### SUBSURFACE INVESTIGATION REPORT

265 CENTRUM BOULEVARD, OTTAWA, ON, K2S 1V4

Report number: 54-BOI-R2<sup>1</sup>

This section provides information to amend this report in response to requests made by the City of Ottawa (C of O). The current request in question is: "MEMO / NOTE DE SERVICE; File No. D02-02-23-0021 & D07-12-23-0033" dated June 13, 2023 and it is in the form of the following numbered list:

Figure 2: Test hole Locations Plan

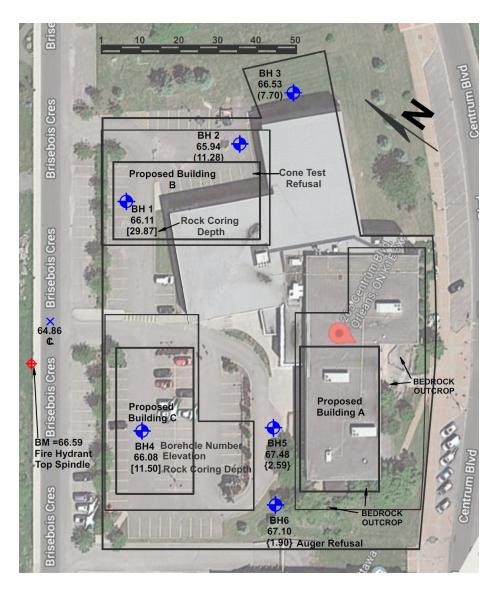
- D1. Please clearly specify the spacing between boreholes. Include discussion in the report and refer to Table 1 in the City of Ottawa Geotechnical Guidelines for the maximum allowable spacing between boreholes and test pits. Note that the Geotechnical Guidelines must be upheld and further boreholes would be required should required spacing not be met.

Figure 2 in page 23 reproduces fig. 1 in page 9 with an added scale bar. It can be seen that the spacing meets the guideline of up to 50 m spacing between holes.

As the guideline must be "upheld" there is no possible outcome by discussing as it is all that matters.
